SECTION 96 MODIFICATION TO DA269/2015:

NORTHERN BEACHES COUNCIL
 THIS PLAN IS TO BE READ IN CONJUNCTION WITH
 Endorsement Date: 20/06/2018
 Mod2018/0180

SOUTH ELEVATION

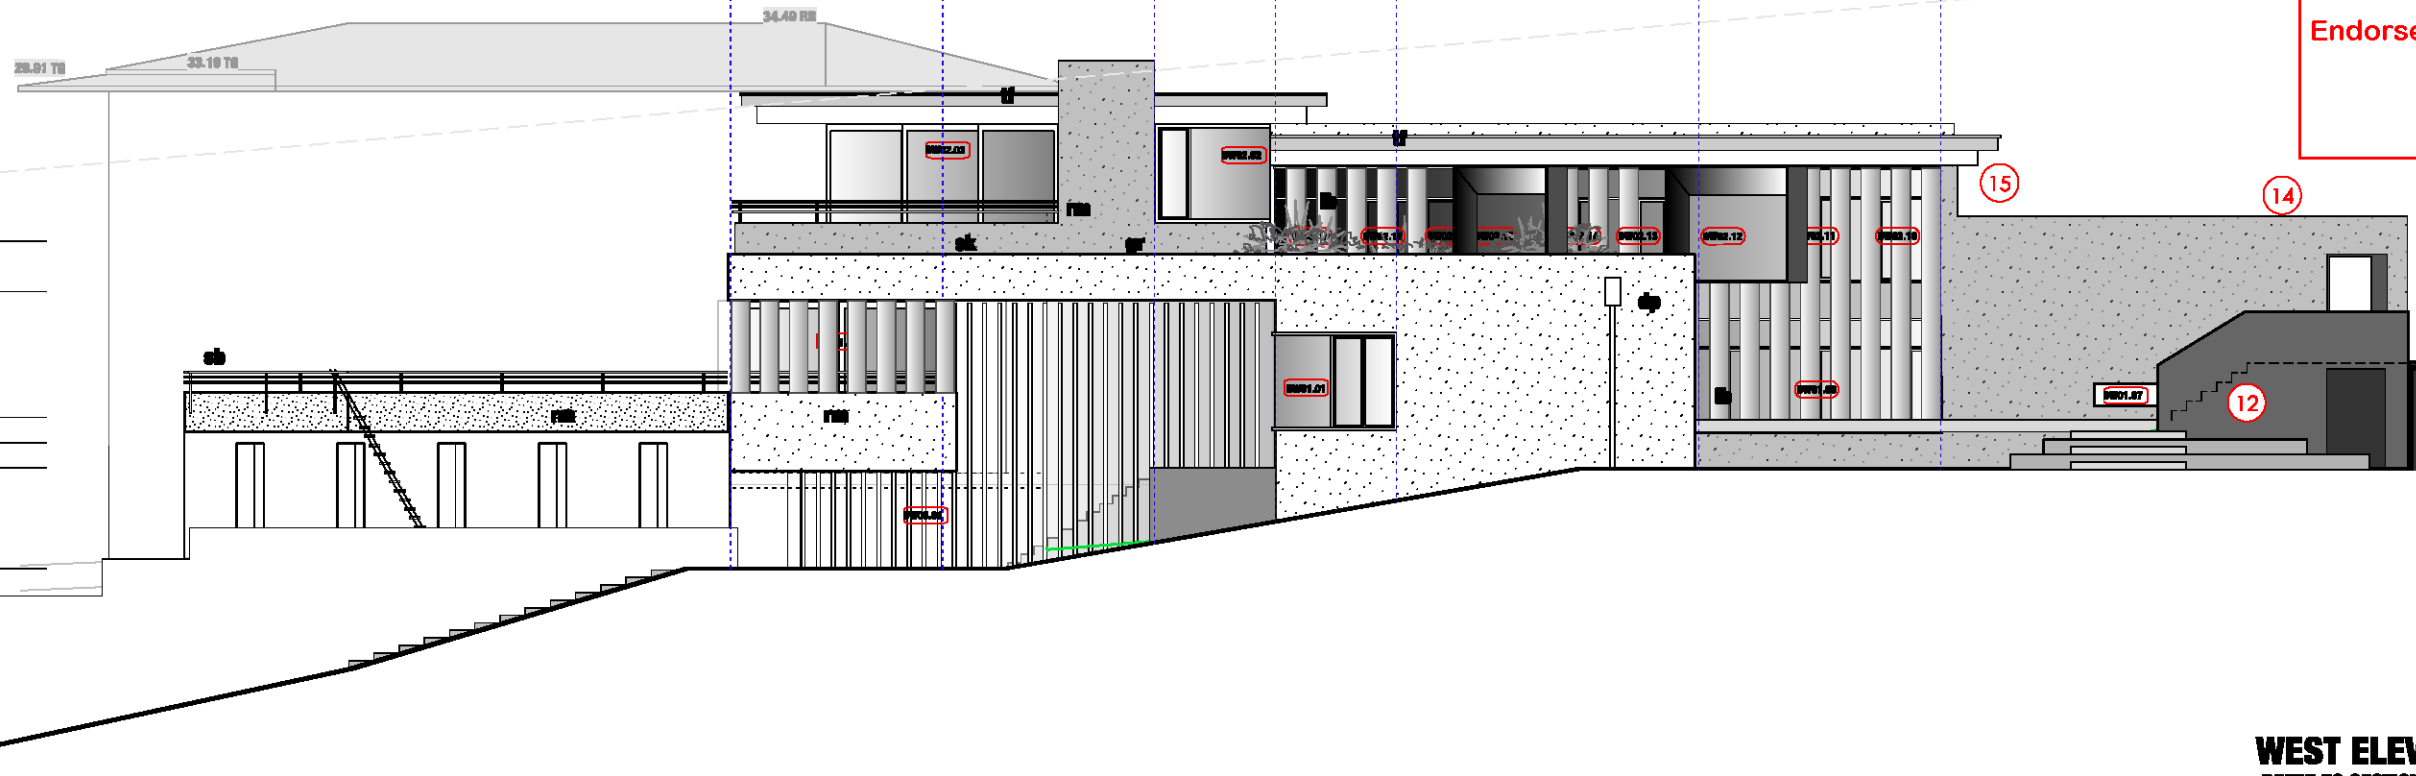
- SECTION 96 MODIFICATION TO DA289/2015:**
1. SWIMMING POOL ADJUSTED.
 2. INTERNAL STAIR RECONFIGURED.
 3. SERVICE AREA RECONFIGURED.
 4. GYM RECONFIGURED.
 5. LIGHTWELL/VOID.
 6. ENSUITE RECONFIGURED.
 7. TREE TO BE REMOVED.
 8. POWDER ROOM RELOCATED.
 9. BATHROOM RELOCATED.
 10. FLOOR LEVEL ADJUSTED RL 25.5 TO RL 26.0
 11. LAUNDRY/CELLAR RECONFIGURED.
 12. ENTRY/STAIR RECONFIGURED.
 13. MAIN ENSUITE RECONFIGURED.
 14. GARAGE PARAPET.
 15. RW DELETED LEFT OVERUN.

SECTION 01

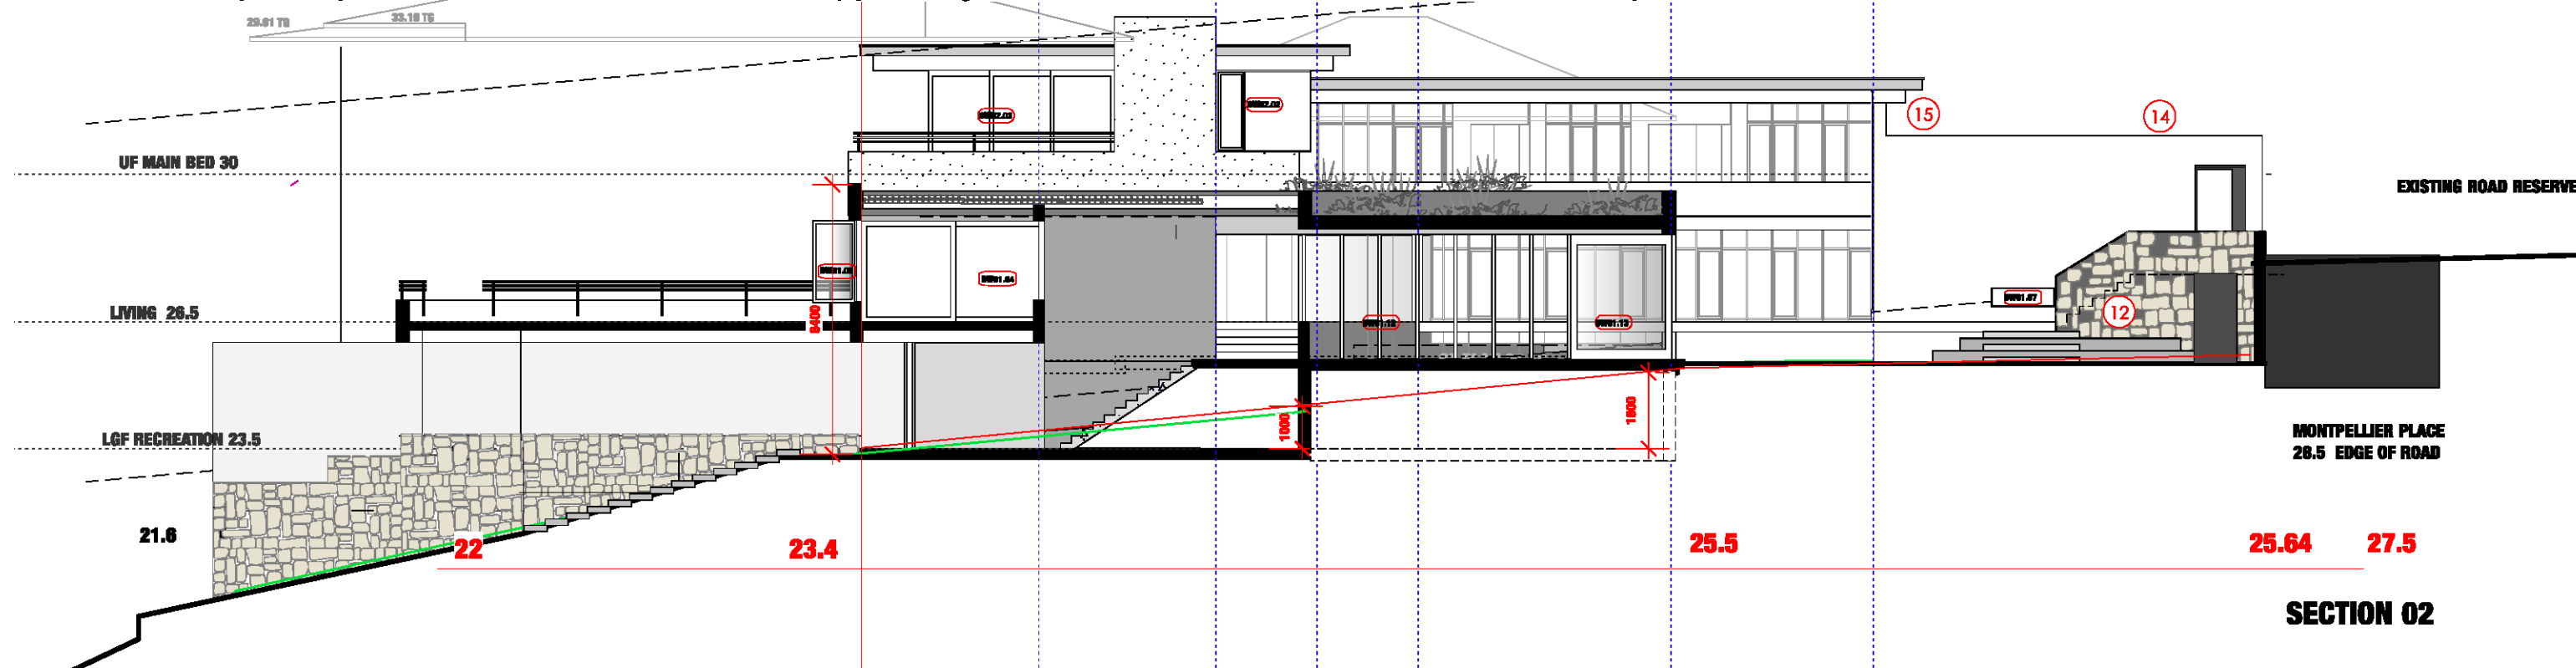
1. SWIMMING POOL ADJUSTED.
2. INTERNAL STAIR RECONFIGURED.
3. SERVICE AREA RECONFIGURED.
4. GYM RECONFIGURED.
5. LIGHTWELL/VOID.
6. ENSUITE RECONFIGURED.
7. TREE TO BE REMOVED.
8. POWDER ROOM RELOCATED.
9. BATHROOM RELOCATED.
10. FLOOR LEVEL ADJUSTED RL 25.5 TO RL 26.0
11. LAUNDRY/CELLAR RECONFIGURED.
12. ENTRY/STAIR RECONFIGURED.
13. MAIN ENSUITE RECONFIGURED.
14. GARAGE PARAPET.
15. BW DELETED LIFT OVERUN.
